# Airworthiness Directive Schedule

### Cessna 210 Series

23 February 2023

**DCA/CESS210/37 Main Landing Gear Saddles – Inspection and Replacement**

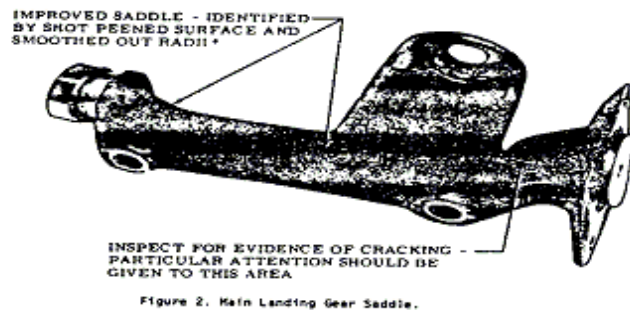
Inspect P/N 1241004-1 and 1241004-2 landing gear saddles for cracks using dye penetrant method in accordance with either procedure 1 or 2 as specified in note 4 and 5 of this AD. Pay particular attention to the critical areas shown in Figure 1 of this AD.

Inspect P/N 1241423-1 and 1241423-2 main landing gear saddles for cracks using dye penetrant method in accordance with either procedure 1 or 2 as specified in note 4 and 5 of this AD. Pay particular attention to the critical areas shown in Figure 2 of this AD.

Inspect the P/N 1241423-1 and 1241423-2 main landing gear saddles for cracks using dye penetrant method in accordance with either procedure 1 or 2 as specified in note 4 and 5 of this AD. Pay particular attention to the critical areas shown in Figure 2 of this AD.

If any cracks are found, replace saddles before further flight.

Replace P/N 1241004-1 and 1241004-2 main landing gear saddles with new parts with P/N per Cessna Service Letter SE 75-26 dated 5 December or later approved revisions.

If any cracks are found, replace saddles before further flight.

Replace P/N 1241423-1 and 1241423-2 main landing gear saddles with improved saddles of the same P/N per Service Letter SE 75-26.
